Subject: Acknowledgement of the Intent of City staff to appeal the preliminary FIRM maps released by FEMA.

Project: Watertown Preliminary FEMA Risk Maps

Subject: Watertown Preliminary FEMA Risk Map Comments

Tributary to Pelican Lake Branch Terrain High Ground

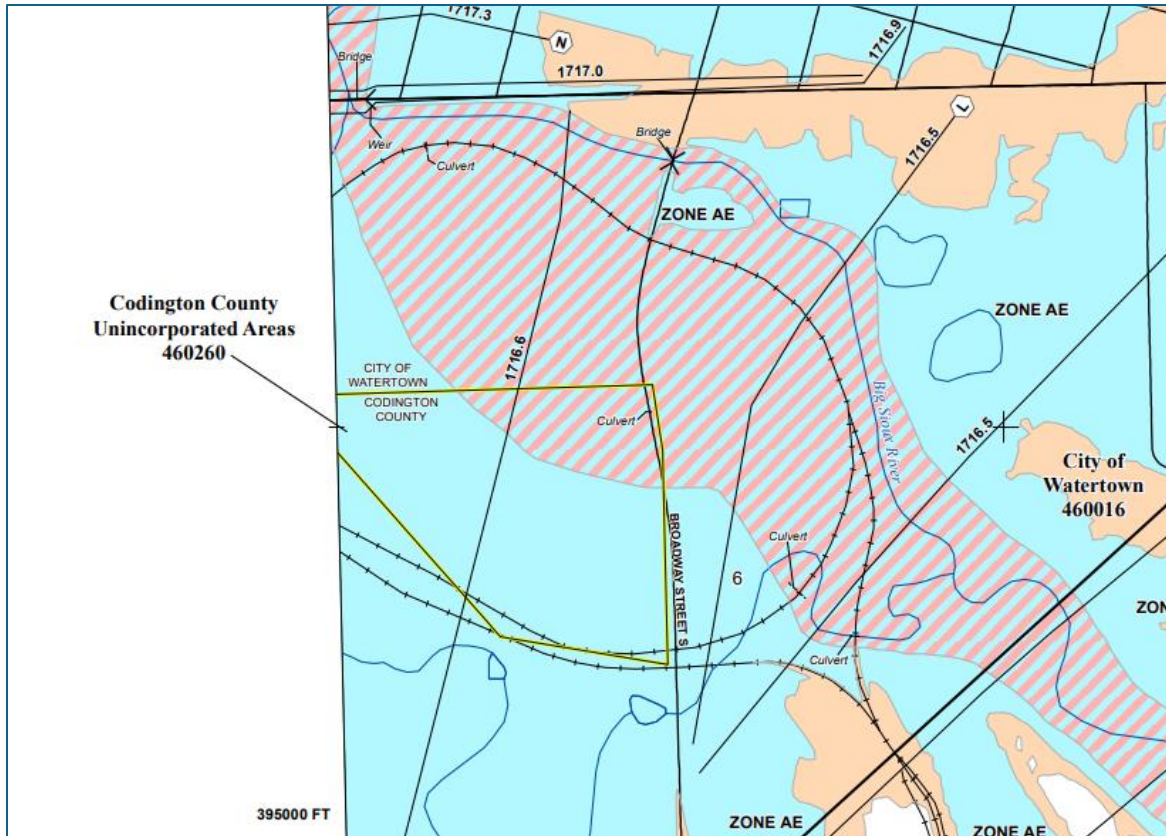
16. Tributary to Pelican Lake Branch Terrain: The terrain for the Tributary to Pelican Lake Branch is inaccurate. There are 2 locations where it looks like high ground crosses through the Tributary as shown in the screen clip below, but the aerial imagery in the following screen clip demonstrates no high ground is found in the channel. The 2021 LiDAR clearly represents the channel correctly and should be used for updates to the preliminary maps.

LOMR Case Number 22-08-0217P Aerial Image of Modifications in the Floodplain

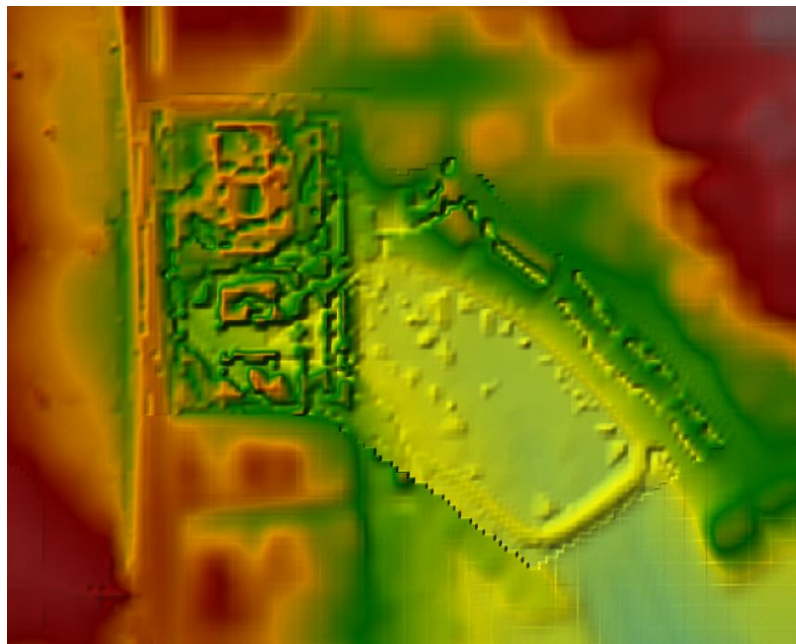
18. **LOMR Case Number 22-08-0217P:** The constructed surface of LOMR Case 22-08-0217P was not incorporated into the model (south of Highway 212 between the Big Sioux River, Tributary to Pelican Lake Branch, and Pelican Lake Branch). The screen clip below shows the mapping update for the railroad tracks and added structures. The floodplain modifications in this area are significant and need to be represented in the preliminary maps. 2021 LiDAR reflects railroad embankment added to the floodplain, but any model revisions will need to incorporate the added structures as well. Not including the LOMR into the preliminary map generates inaccurate results in the modeling and mapping, and the models and maps should be updated to incorporate these modifications to the floodplain that have already been approved by FEMA through the proper LOMR process.

HEC-RAS surface

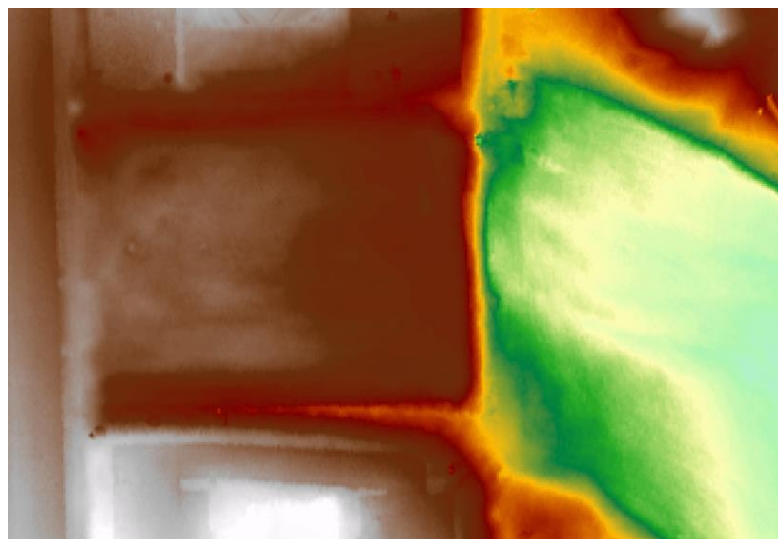
19. **LOMR Case Number 17-08-0664P:** The supporting documentation for the mapping project indicates that LOMR 17-08-0664P was incorporated into the remapping efforts of Roby Creek. It appears the surface was modified in the HEC-RAS model in this area, but the surface meshed into the model does not represent the current or past conditions of the site. The model surface ungulates and does not match the final smooth graded surface depicted in the 2021 LiDAR as shown in the screen clips below. It is unclear what surface was used in the model, but the elevations and grading do not depict the actual site conditions and generates an inaccurate map at the site since the majority of the actual site is above the BFE according to the 2012 and 2021 LiDAR.

Pelican Lake Branch Preliminary FIRM (46029C0319E) with Floodway

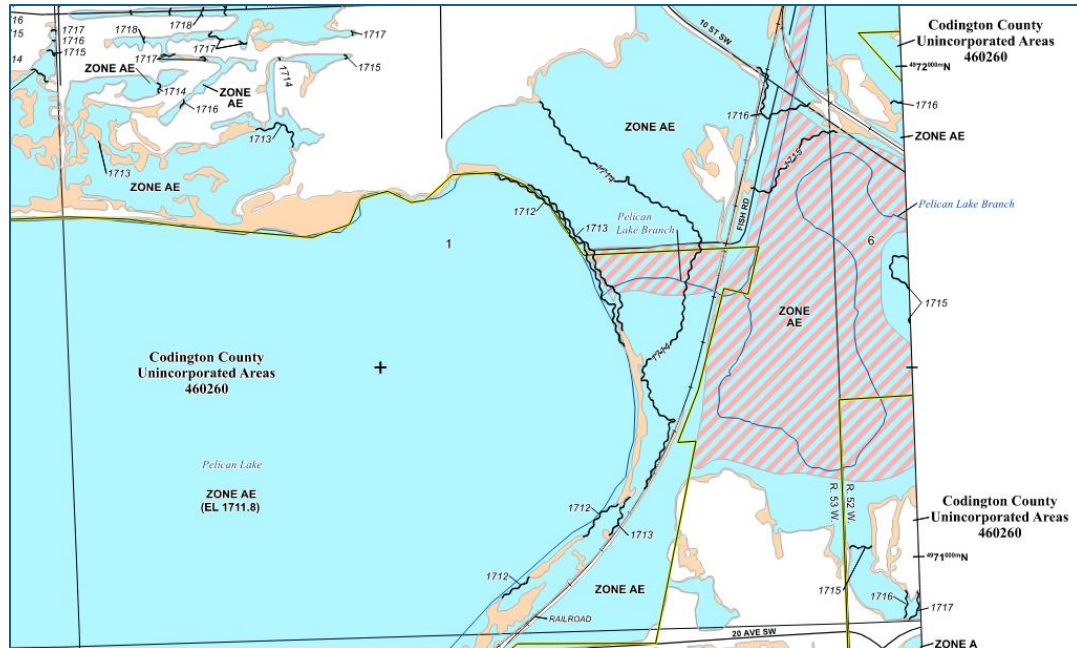
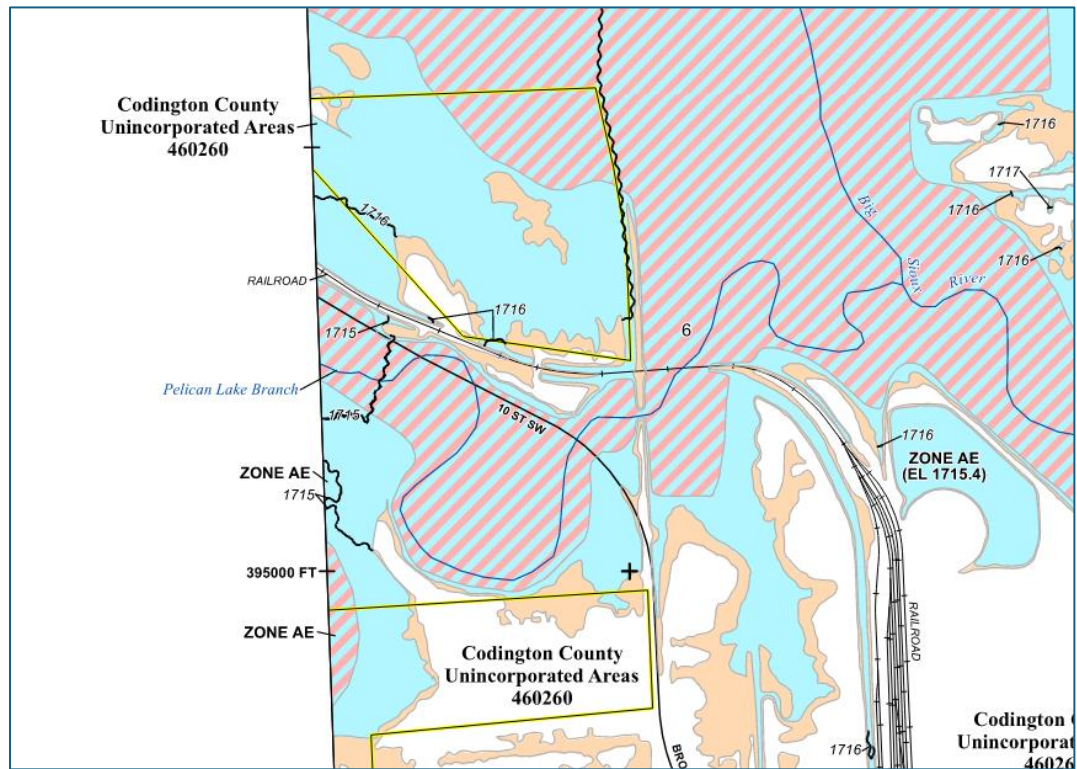
The area of specific concern is the Pelican Lake Branch which is mapped as floodway and found on Preliminary FIRMs 46029C0338E and 46029C0319E as shown in the screen clips below. It is evident in the model that channel bathymetry was not available, and the modeling team modified the model terrain to have an arbitrary bottom elevation of 1709.72 ft (NAVD 88) for a portion of the reach and 1709.38 ft (NAVD 88) for another area. LiDAR of the area does not depict these same channel elevations as shown in the model, and there is no documentation of channel survey to justify the channel elevations used. The modification of the channel bottom allows for additional water volume storage in the reach and improves conveyance capacity through the Pelican Lake Branch which likely generates BFE’s that are not accurate for this detailed reach, Pelican Lake, and potentially the Big Sioux River.

It is also unclear what information was used for the Big Sioux River channel bathymetry. Documentation does not discuss model channel bathymetry or survey of channel bathymetry, but it appears modifications were made to the bathymetry in the model based on the LiDAR. The lack of documentation and information provided by FEMA to the City makes it impossible to verify survey information was used to define the bathymetry of the Big Sioux River correctly.

Luther Lane Culvert Blocked

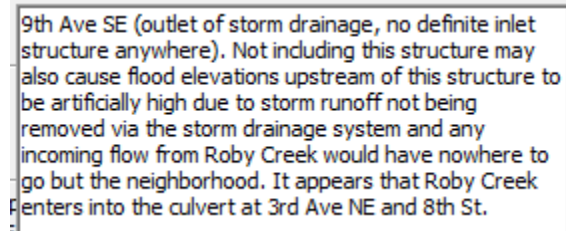
For the majority of the culverts along Roby Creek, channel culverts are artificially blocked by a half a pipe diameter or more which reduces conveyance capacity of these structures by over 50% or more. Taking an approach of artificially blocking structure conveyance capacity by over 50% to allow the model run appears to artificially create additional backwater in the model, increases base flood elevations, and creates a false hydraulic representation of the structure's true conveyance capacity. Luther Lane on Roby Creek is an example of a culvert blocked by 73% as shown in the screen clip below.
